REMARKS

Amendments to Drawings

FIGURE 1

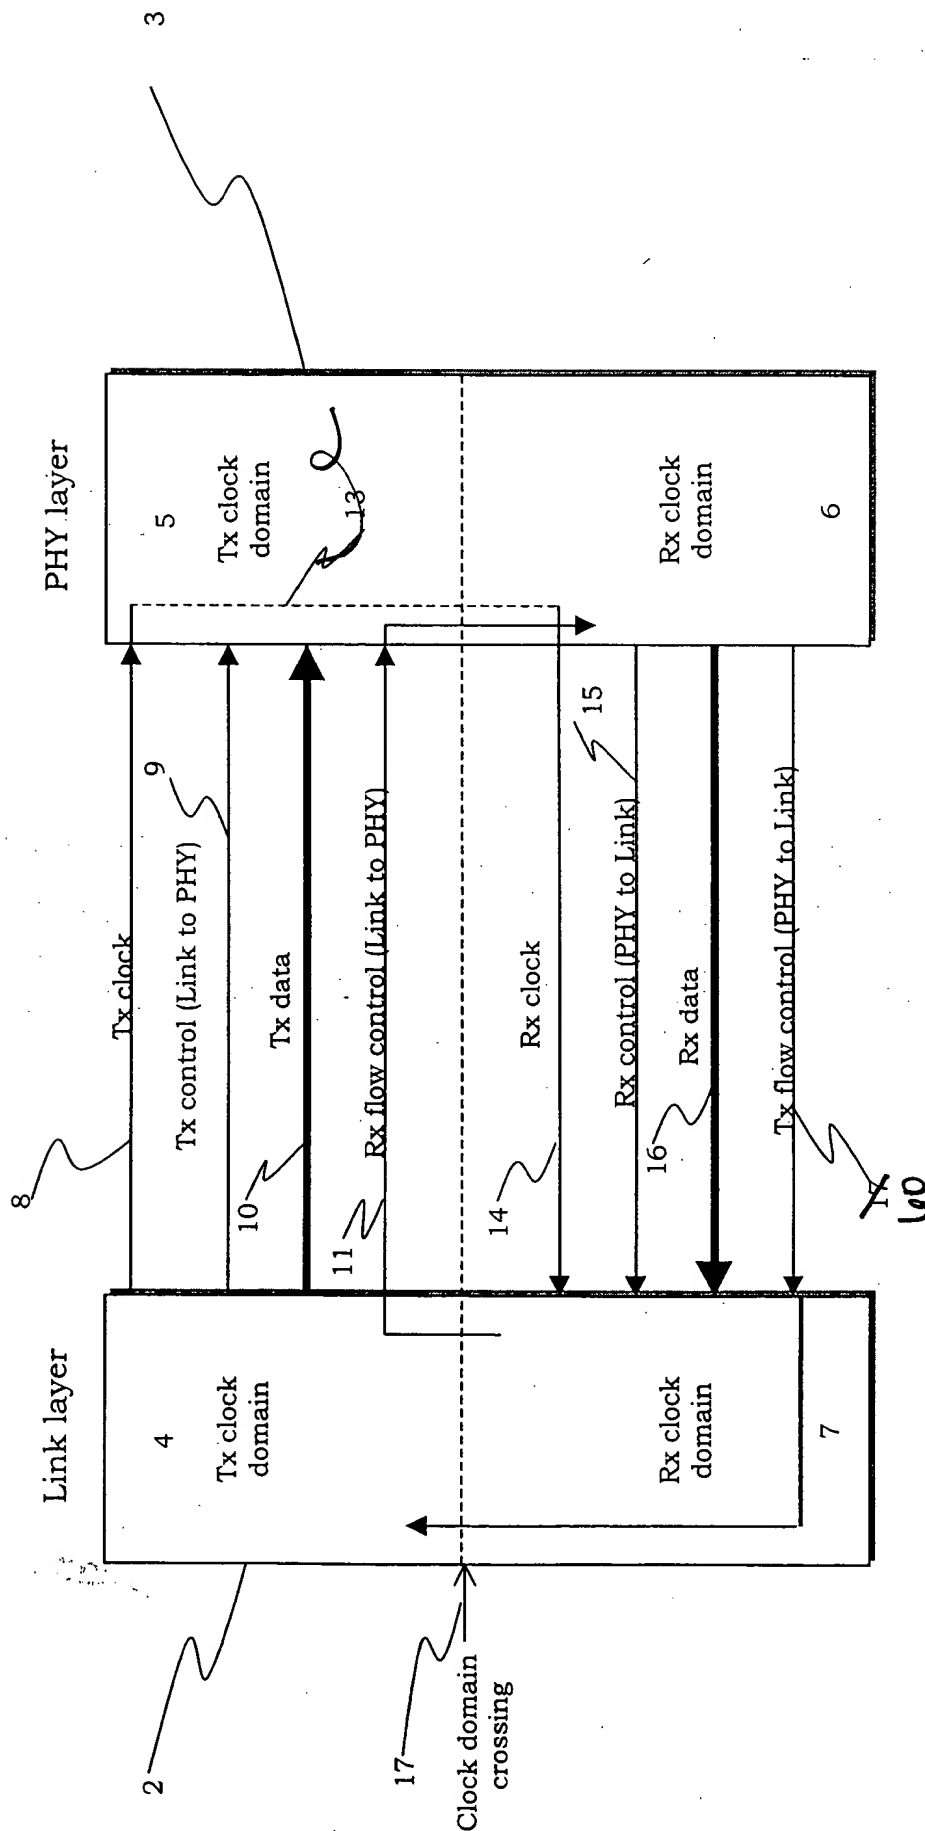
FIGs. 1 and 2 have been amended to delete reference numerals 12 and 13 respectively. Additionally, FIG. 1 has been amended to replace reference numeral 17, used to describe the TX flow control signal, with reference numeral 60. The detailed description has been amended to reflect the use of reference numeral 60.
